TECHNICAL BULLETIN

ENGINE AUTOMATIC RE-IGNITION MODIFICATION

All Model 369H/HE/HM/HS/D series helicopters with engine automatic re-ignition kit installed.

369H90118 engine automatic re-ignition kit.

Figure 1. Engine Automatic Re-Ignition Indicator Light

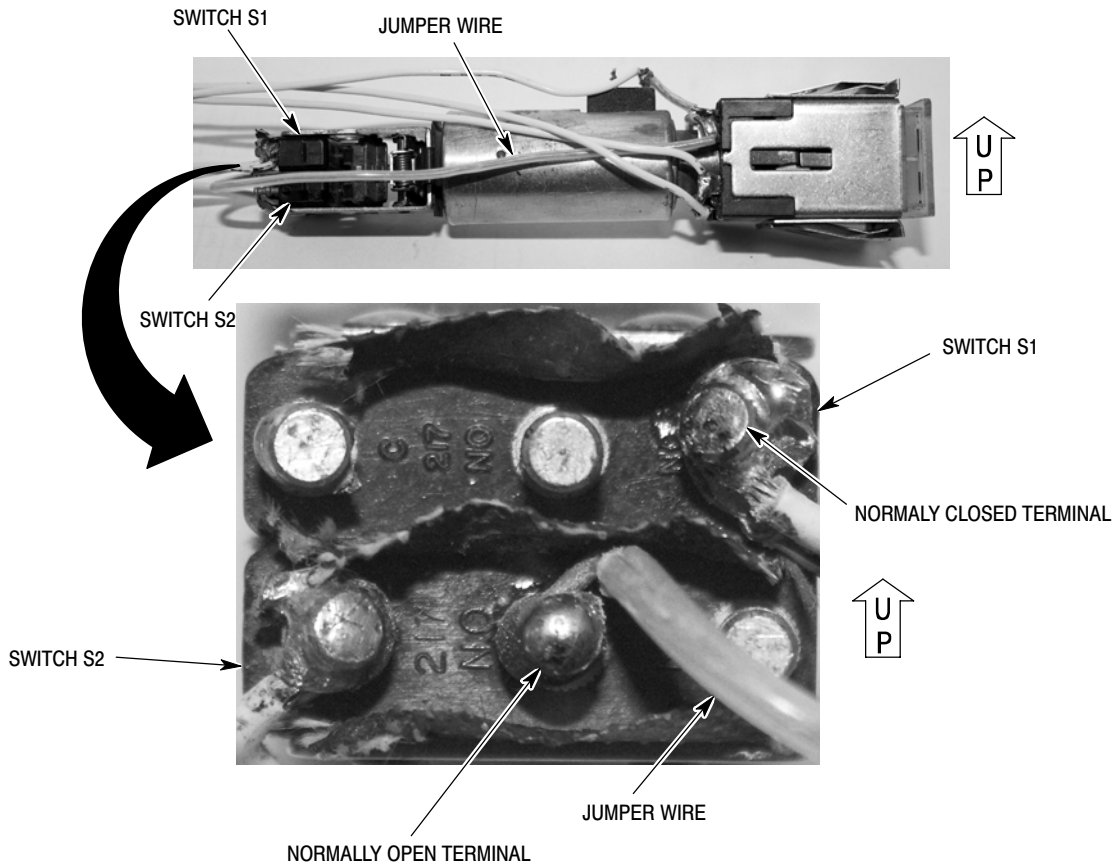
To disconnect a defective switch in the XDS9 assembly from the system because replacement switches are not available. Also to change the manual reset function of the XDS9 engine automatic re-ignition (**RE-IGN**) indicator light to automatic reset after engine re-ignition.

This modification disconnects the wires from the switch in the XDS9 assembly from the system. The disconnected wires are then spliced together to make the XDS9 **RE-IGN** indicator light reset automatically after engine re-ignition.

- (1). 369H/HE/HM/HS helicopter, get access to the rear end of XDS9 light assembly (Ref. CSP-H-2 Basic Handbook of Maintenance Instructions and CSP-H-3 Optional Equipment Manual).

- (2). 369D helicopter, get access to the rear end of XDS9 light assembly (Ref. CSP-HMI-3 Handbook of Maintenance Instruction, Instruments - Electrical - Avionics).

- (8). Remove, or apply black paint to, the **PRESS TO RESET** decal on the engine automatic re-ignition switch panel.
